PERFORMANCE SPECIFICATION SHEET

SWITCH, PUSHBUTTON, ILLUMINATED, 4-LAMP 0.750 SQUARE, LOW LEVEL TO 7 AMPERES,
(DRIPPROOF, EMI/RFI SHIELDING, NIGHT VISION GOGGLE COMPATIBLE)

This amendment forms a part of MIL-PRF-22885/90C, dated 17 March 1999, and is approved for use by all Departments and Agencies of the Department of Defense.

ONE, TWO, OR THREE
POLE ARRANGEMENTS

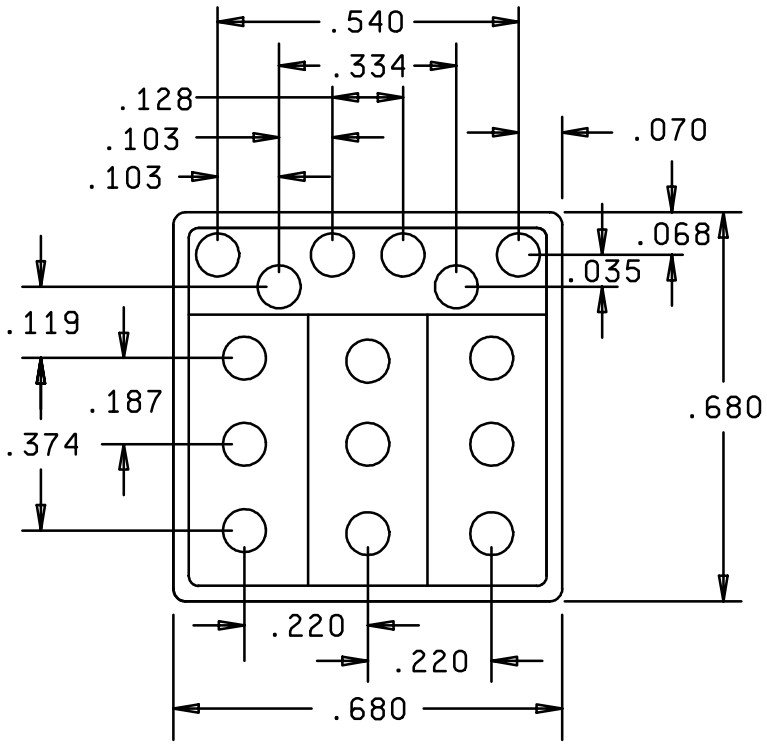
Figure 5, rear view, one, two or three pole arrangements, delete and substitute:
